PRODUCT CHANGE NOTICE

PCN#22-037

RC-1SPDT-A18
RC-2SPDT-A18

Upgrade of mechanical switch design

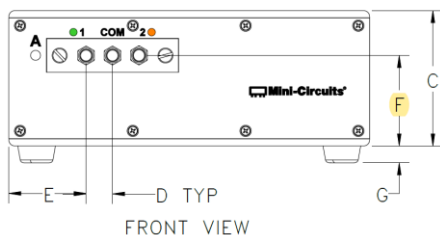
- Electrical Specification Changes for both models

Attribute	Before	After
RF Power (Cold Switching)	Max: 20W	Max: 40W
Switching Time	Typ.: 25ms	Typ.: 15ms
Switch Life	Typ.: 10 million cycles	Typ.: 5 million cycles

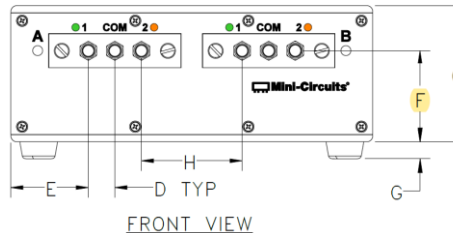
- Minor Changes to Switch Positions:

Model	Attribute	Before	After
RC-1SPDT-A18	Dimension F	1.47" (37.3)	1.50" (38.2)
RC-2SPDT-A18	Dimension F	1.47" (37.3)	1.50" (38.2)
